Carmichael Coal Mine

Advice on Groundwater Dependent Ecosystem Management Plan
v11b to the Queensland Department of Environment and Science

JUNE 2019

Figure 2 Location of groundwater monitoring bores listed in Appendix B of GDEMP v11b and springs in the Doongmabulla Spring Complex (DSC), including Joshua Spring to the west of the proposed mine.

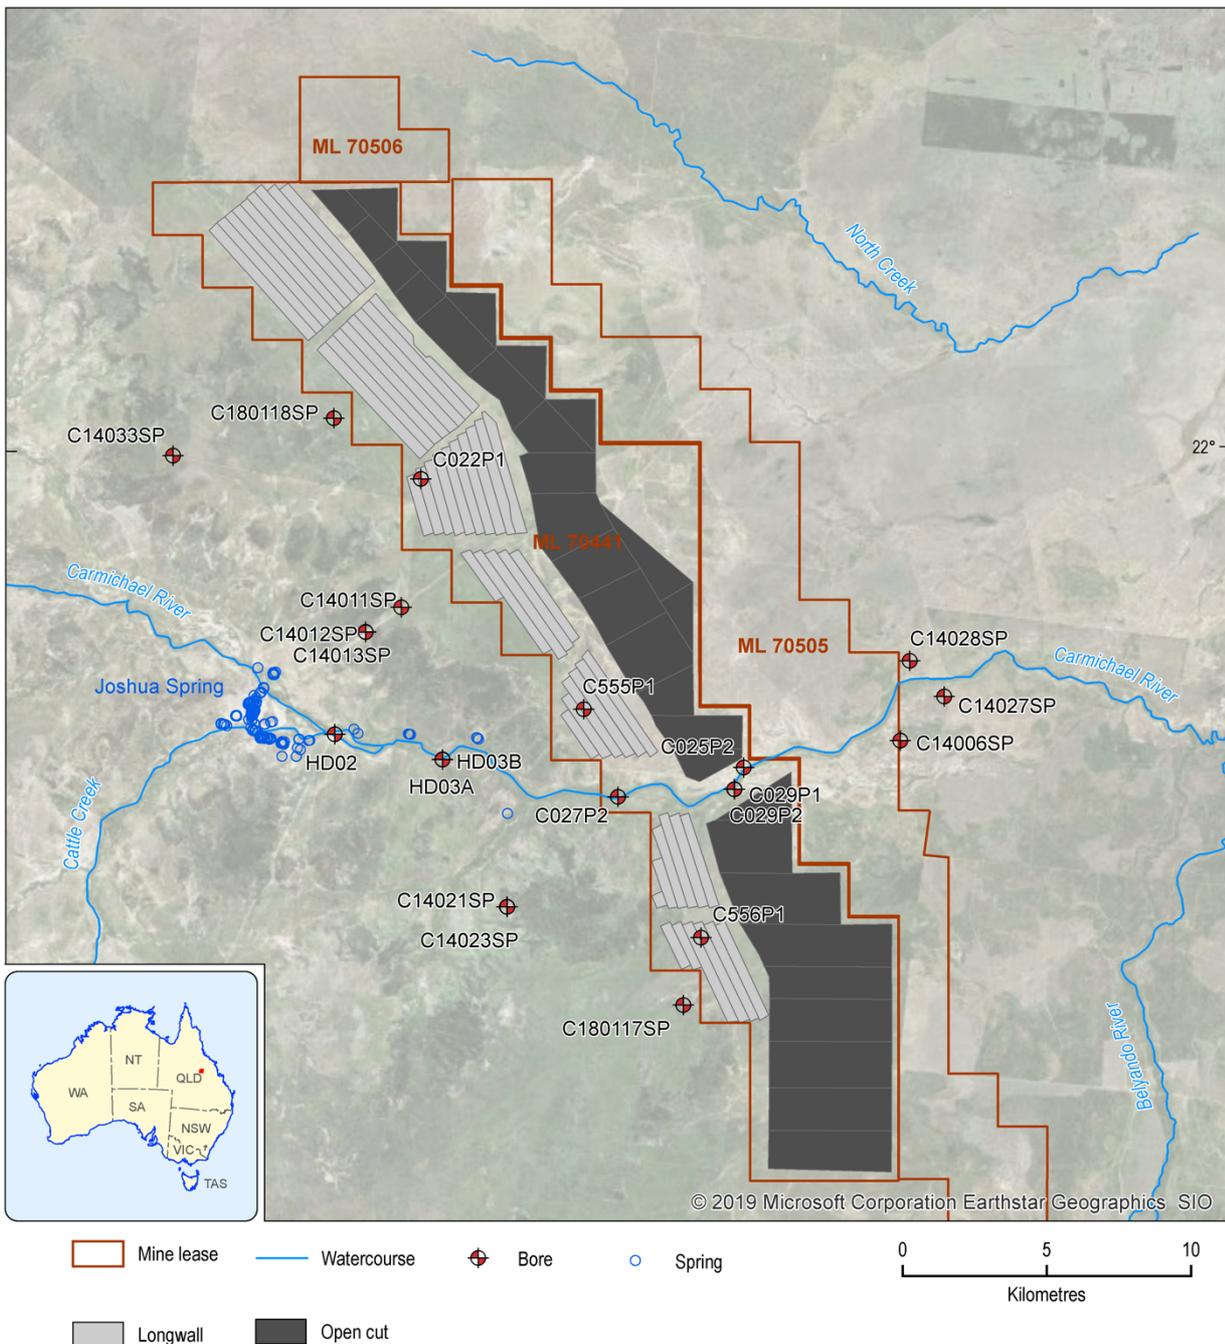
Issue: Groundwater drawdown trigger thresholds are not suitable for detecting drawdown rates in a timeframe that is comparable with routine monitoring data assessment and agreed groundwater model review periods.

CSIRO/GA advice to DoEE on the groundwater drawdown trigger thresholds recommends that “all monitoring locations for which water level thresholds are defined should also have drawdown rate limits derived. Evaluation of drawdown rate limits should form part of routine monitoring data assessment and be included in the Impact Threshold Assessment approach” (DoEE, 2019). The updated GMMP describes interim drawdown rate triggers (Table 46 of GMMP v8) for three bores (C022P1 – Dunda Beds, and C555P1, C556P1 – Rewan Formation, Figure 2) that specify predicted groundwater drawdown magnitude and rates over the next 0-2, 3-7, 8-12, 13-17 and 18-22 years.

Recommendation: Groundwater drawdown trigger thresholds should be set for all monitoring locations for which water level thresholds are defined, using a timeframe that is comparable with routine monitoring data assessment and agreed groundwater model review periods. Further, bore locations should consider localised changes that may impact on groundwater-dependent ecosystems and changes to groundwater conditions following planned longwall panel excavation beneath two of the three interim drawdown rate triggers bores. It is recommended that new groundwater drawdown trigger threshold bores are installed/identified as mining progresses.

Figure 3 Plot of predicted drawdown, early warning (low) and (high) impact thresholds for bore C022P1 – Dunda Beds from Appendix E of GMMPv7

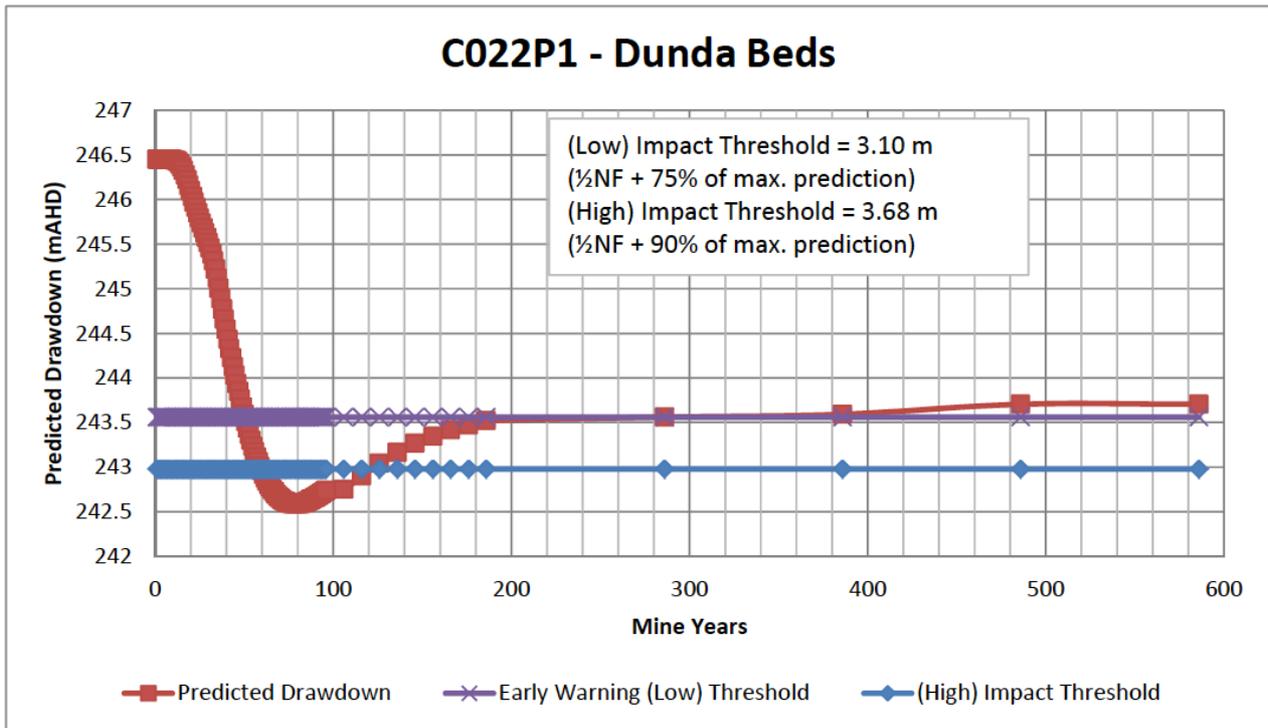
For bore C022P1 in the Dunda Beds, the interim drawdown rate trigger level is 0.48 m over the next 22 years, compared to the early warning trigger level (2.9 m after 50 years) and the (High) impact threshold (3.31 m after 60 years) (Figure 3). This demonstrates the importance of using a timeframe that is comparable with routine monitoring data assessment and the agreed review periods (2 years after the commencement of the box cut and then every 5 years).
